PLANNING & ZONING CASE NO. SP2020-007

Project Name: 1480 Justin Rd.

RE: REVISION NARRATIVE – AMENDED SITE PLAN SUBMITTAL

SPR PACKAGING
OFFICE ADDITION
1480 JUSTIN RD., ROCKWALL, TEXAS

job no 1854
sheet
L1.01

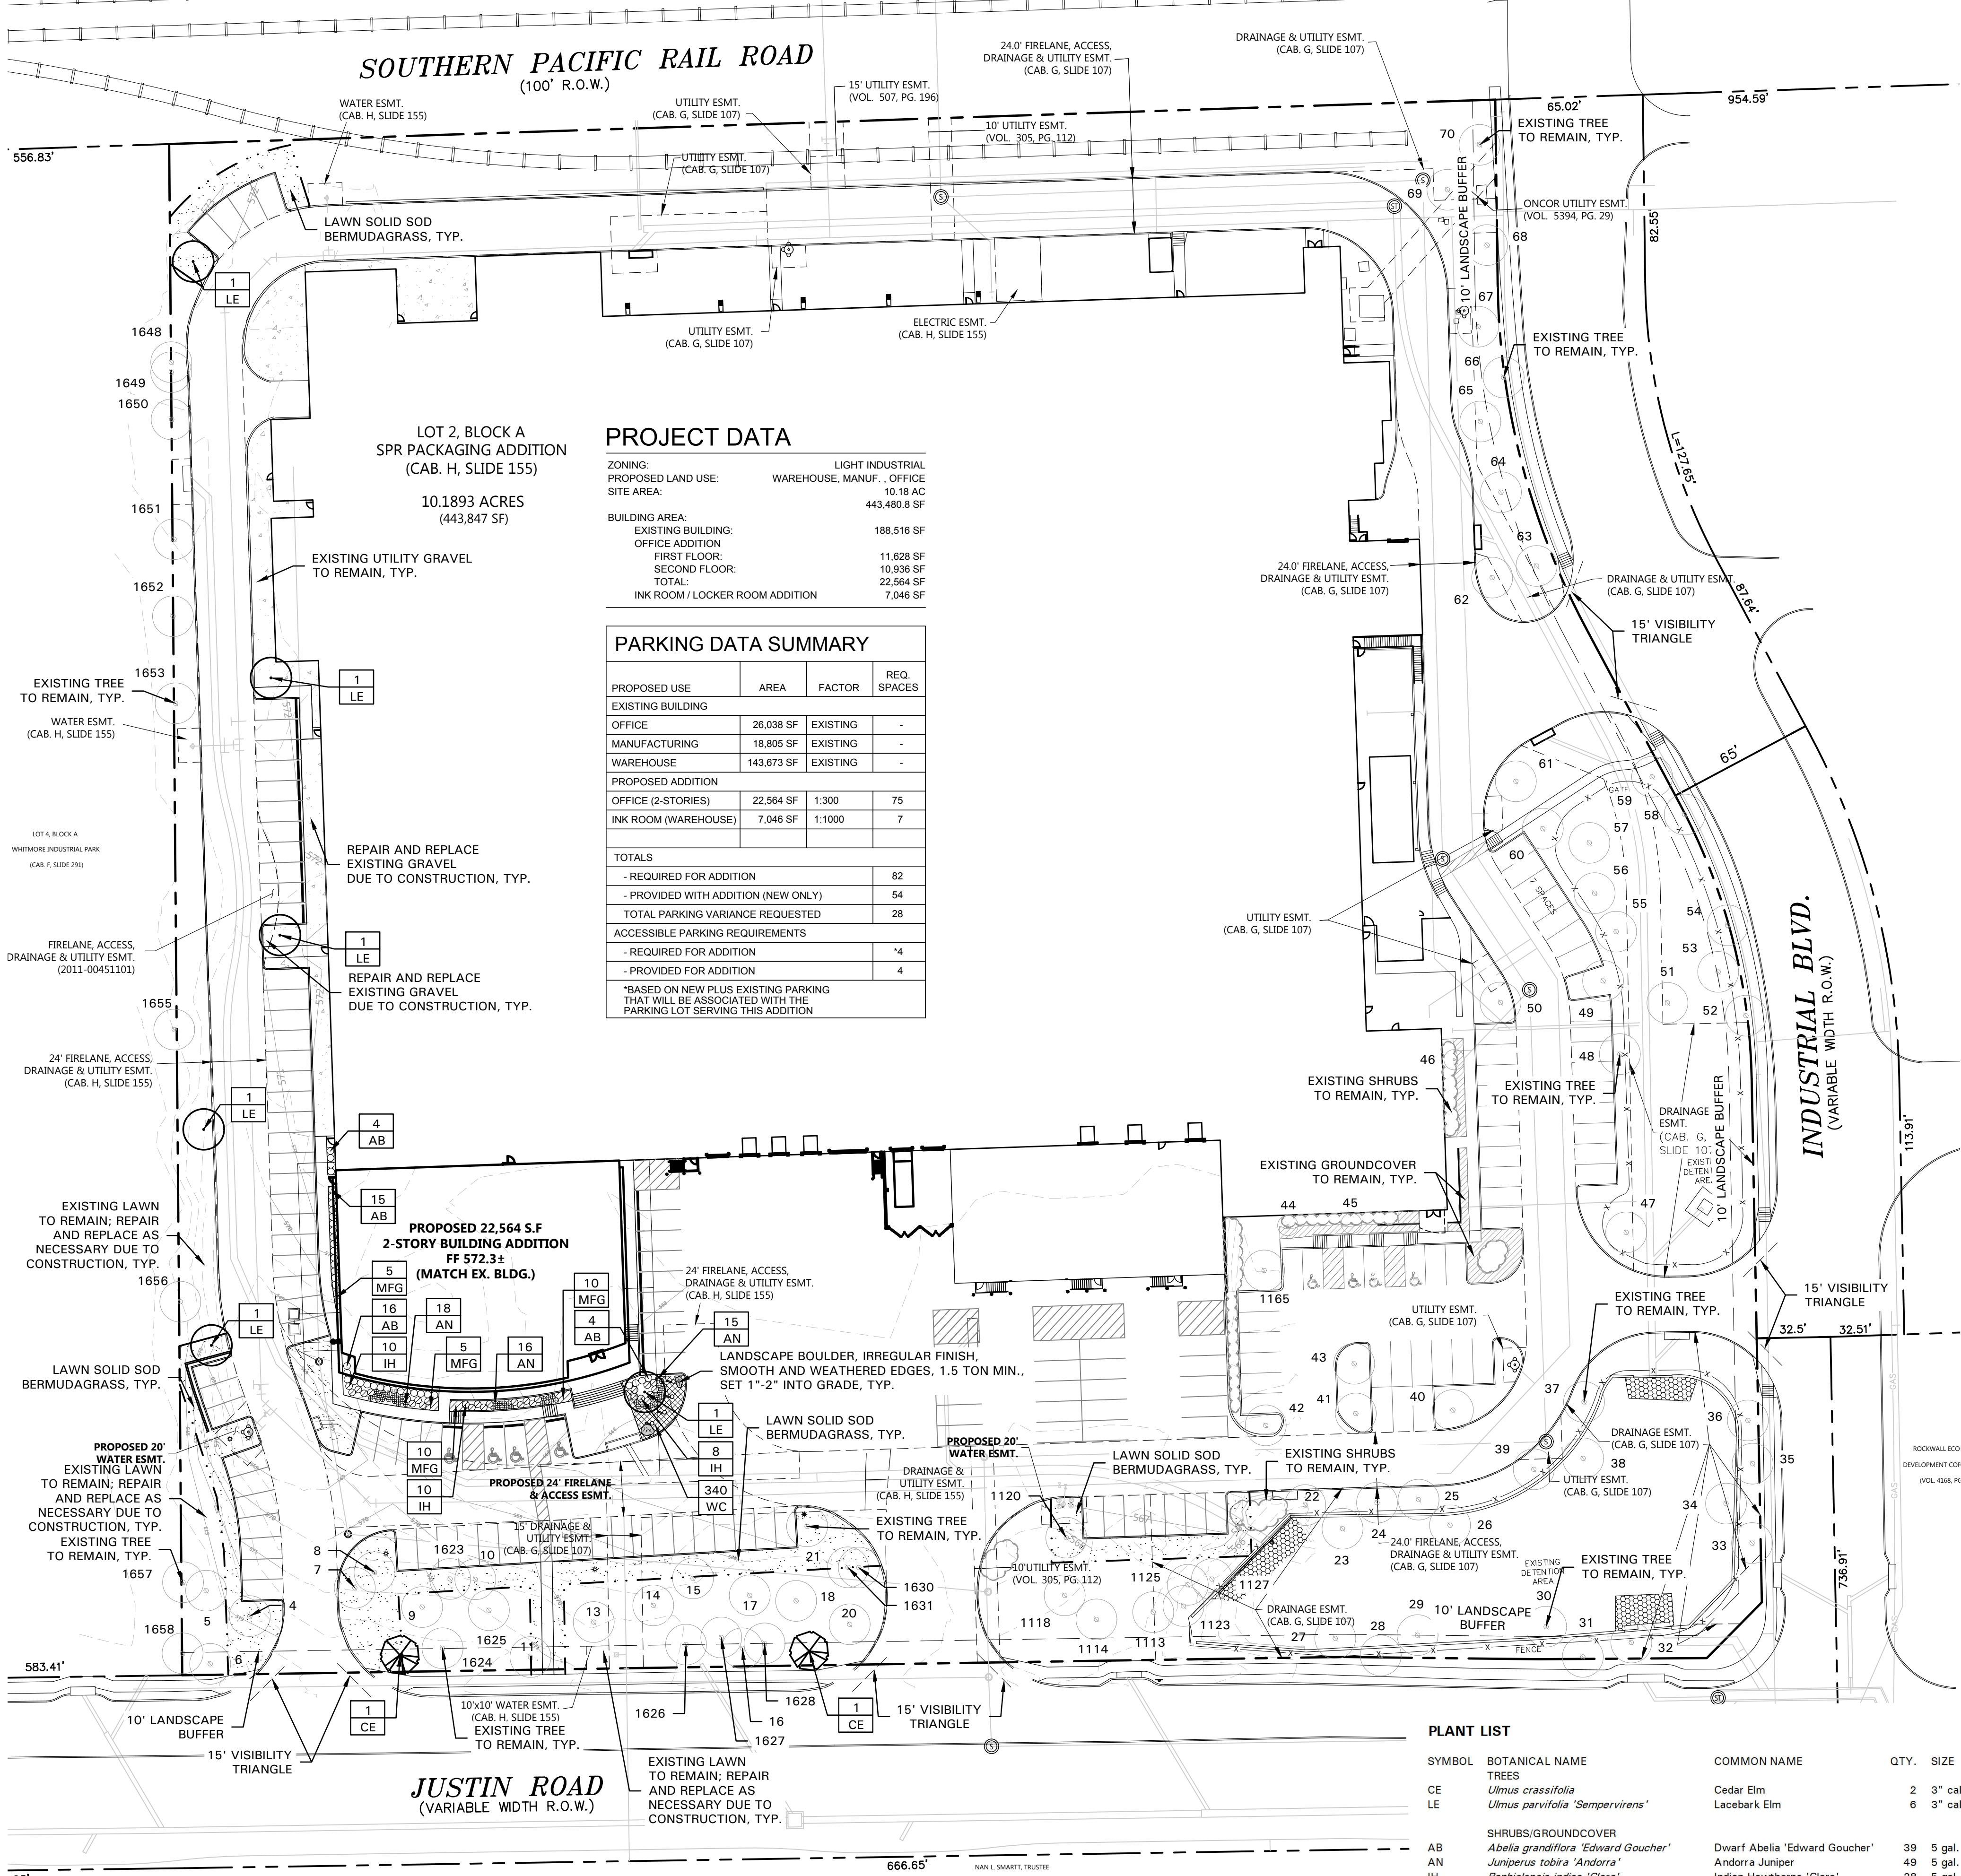
- Revised to show the removal of tree 1654 along the west drive.

job no
1854
sheet
L3.01

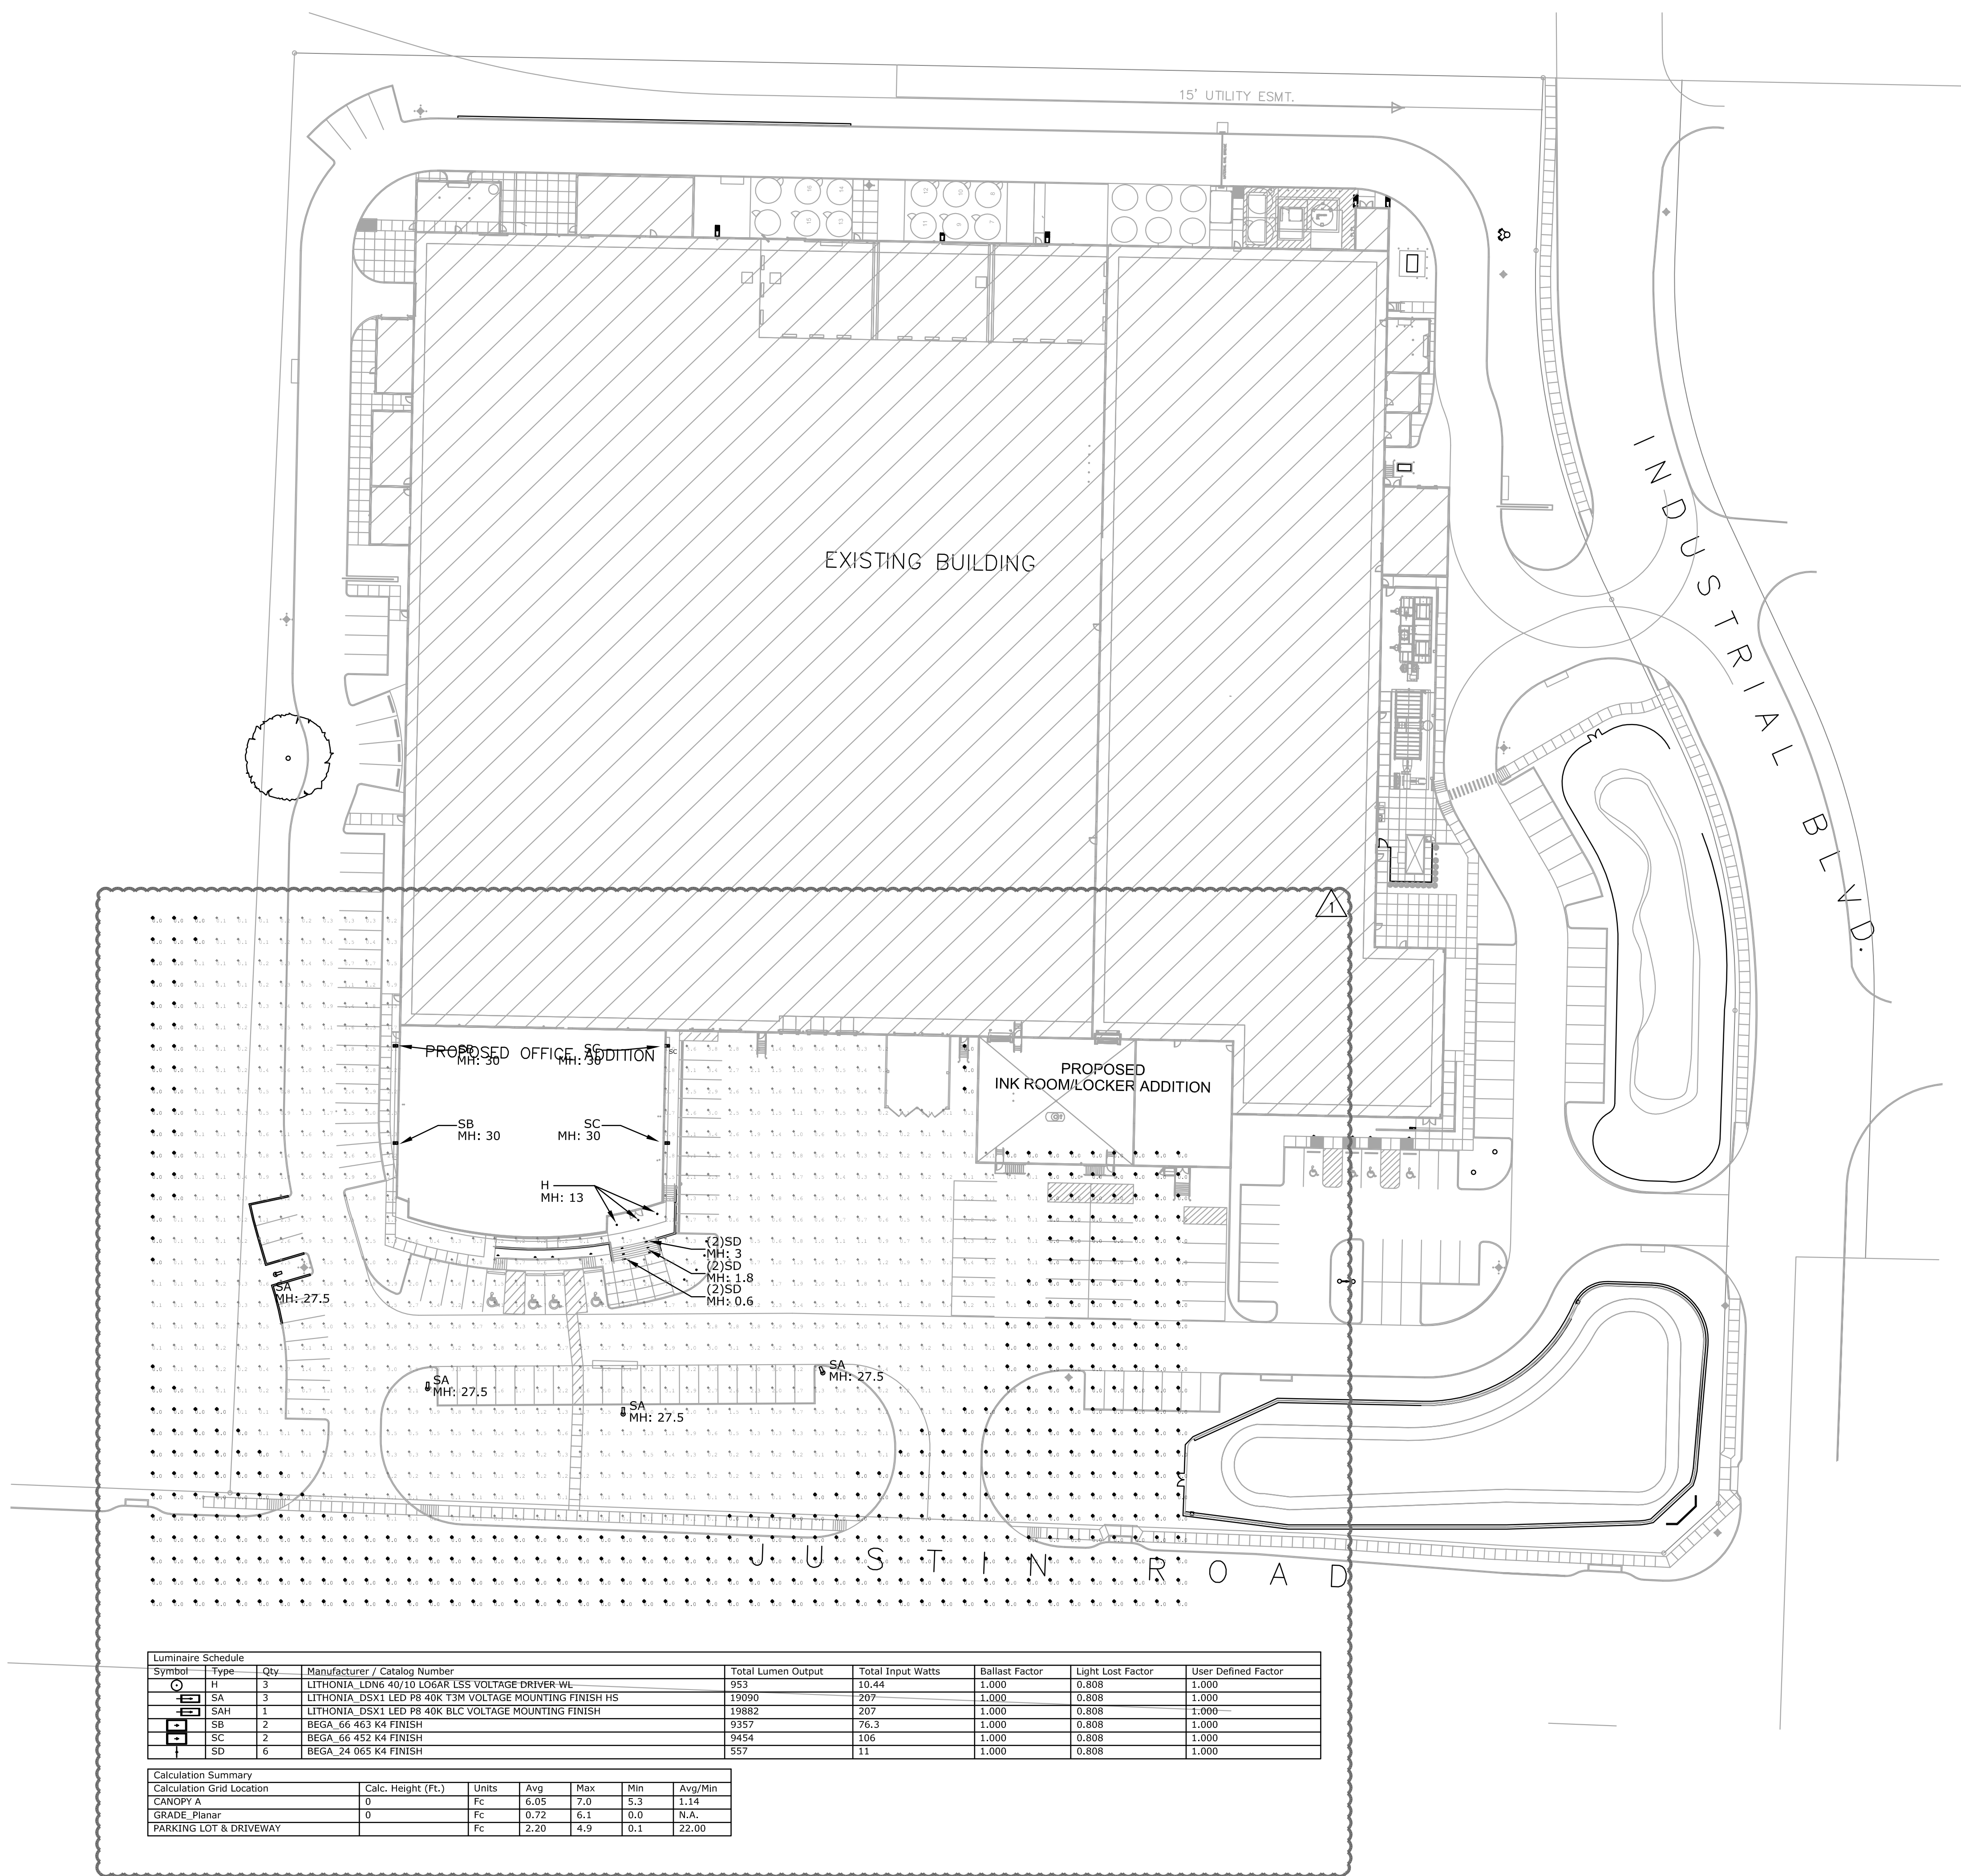
- Revised irrigation design along the new parking configuration and affected drive areas.
